Subject: [Departmental Comments (Batch 2)] Planning Application No. A/YL-SK/445 - Temporary Logistics Centre and Workshop for a Period of 3 Years

I refer to the planning application No. A/YL-SK/445 for Temporary Logistics Centre and Workshop for a Period of 3 Years at Lots 580 (Part), 595, and 598 S.B. (Part), D.D. 114, Wong Chuk Yuen, Shek Kong, Yuen Long.

Comments of the Director of Fire Services (Contact Person: Mr. YUEN Tsz-fung (Tel: [REDACTED]))

DRAWING TITLE
PROPOSED FSI LAYOUT PLAN FOR STRUCTURE
A

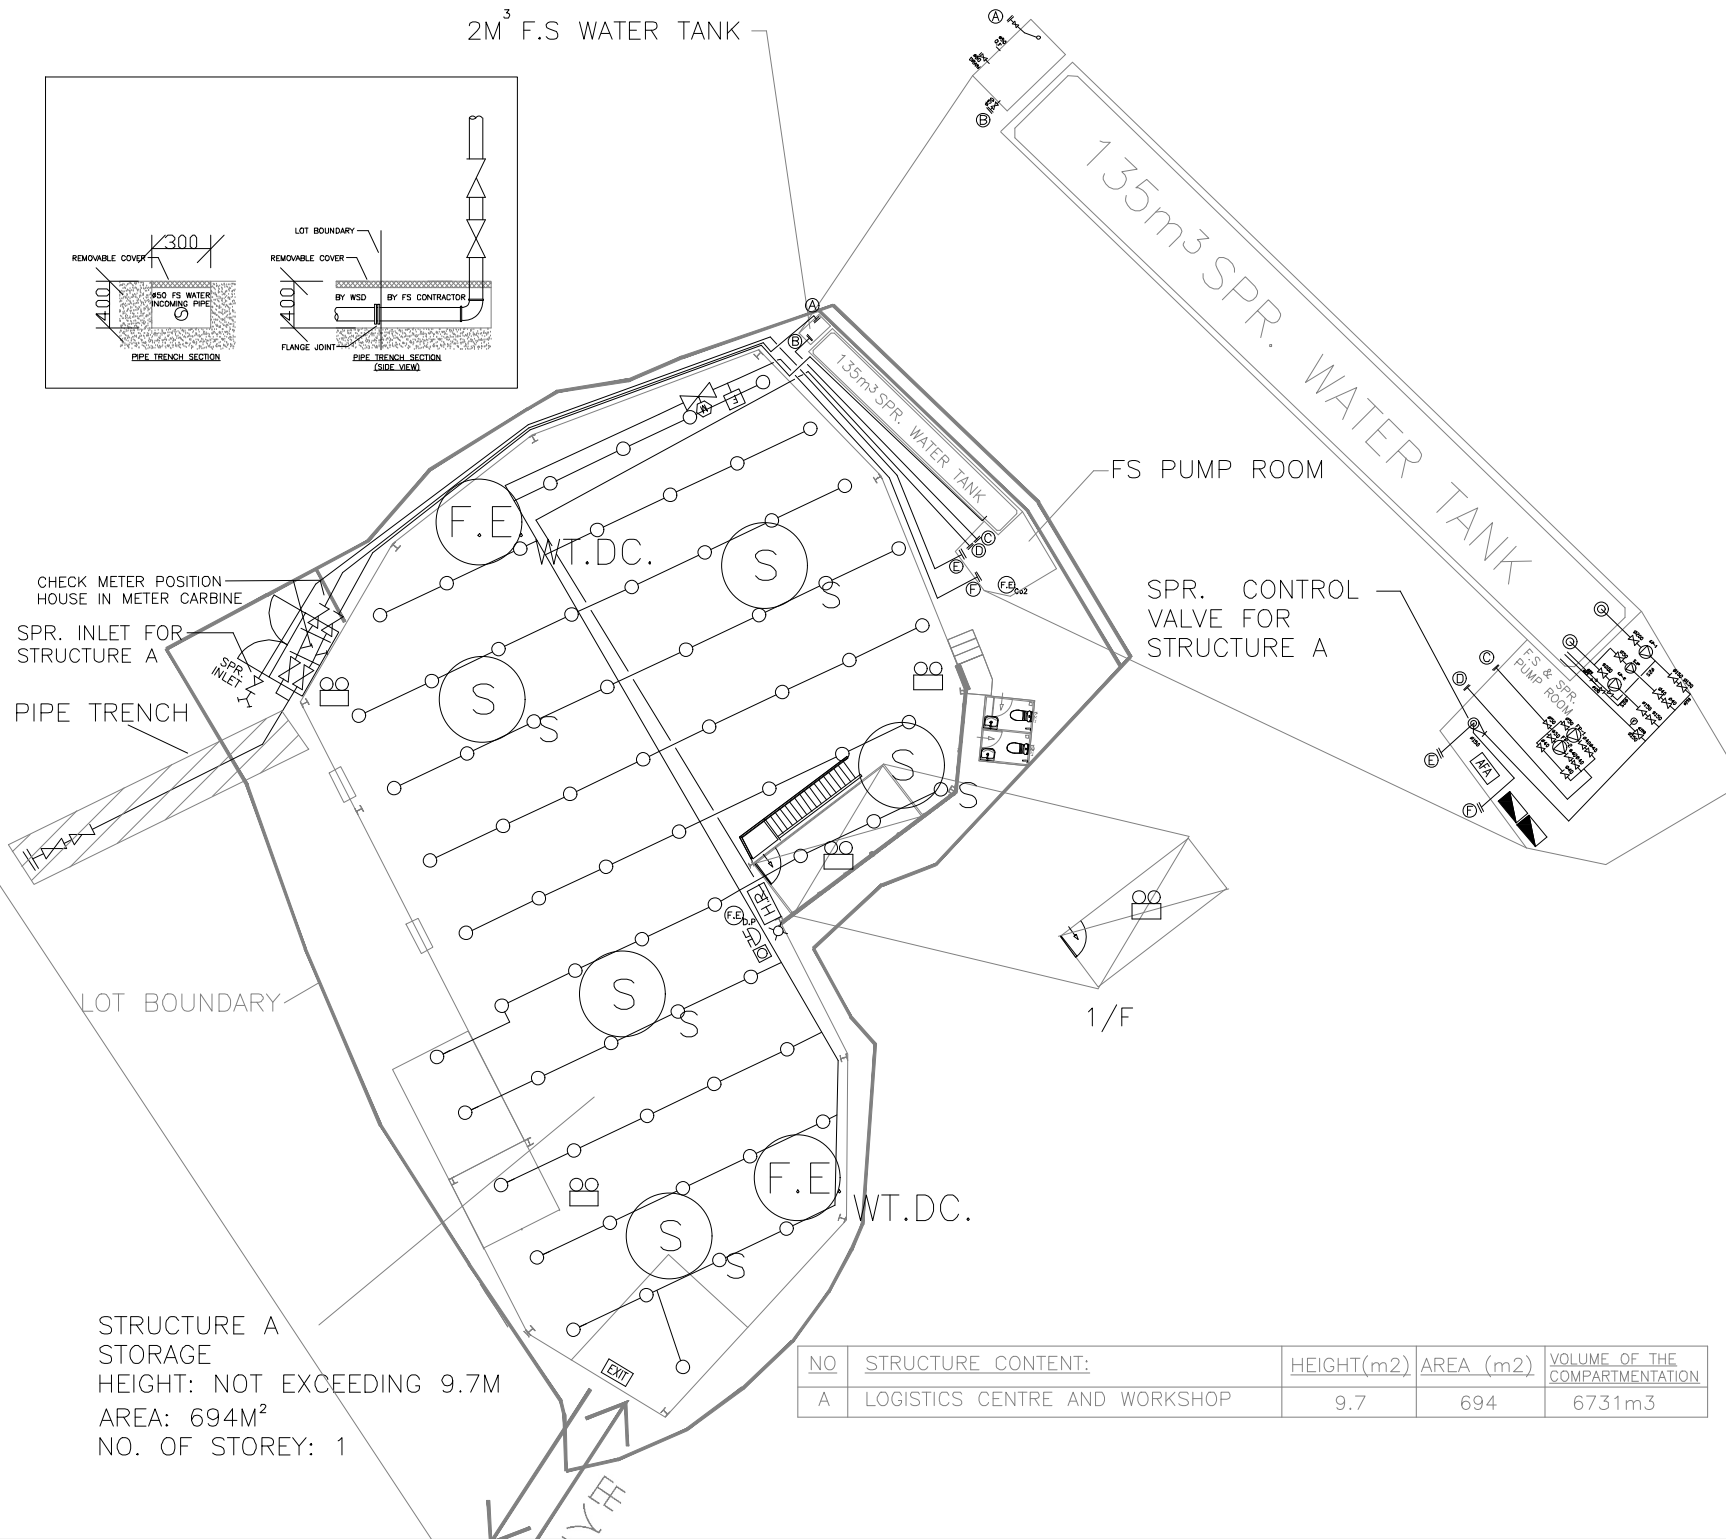
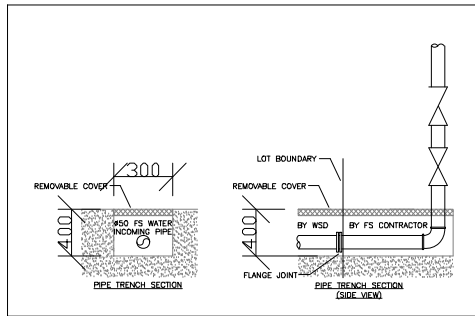
- ix. Schematic drawings are not required to be submitted for vetting;
- x. The structure number specified in items 1.1, 2.1 and 3.1 of the FS Notes for Structure A shall be rectified;

- xi. A complete set of legible FSI proposal shall be provided for Structure A;
- xii. The maximum storage area of a single block (i.e. 50 m²), storage configuration and height regarding the provision of automatic sprinkler system shall be specified in the FS Notes for Structure A;

- xiii. The sprinkler inlets shall be positioned in a prominent position on the exterior of Structure A;
- xiv. Emergency lighting, directional and exit signs shall be clearly indicated on the plan for Structure B; and
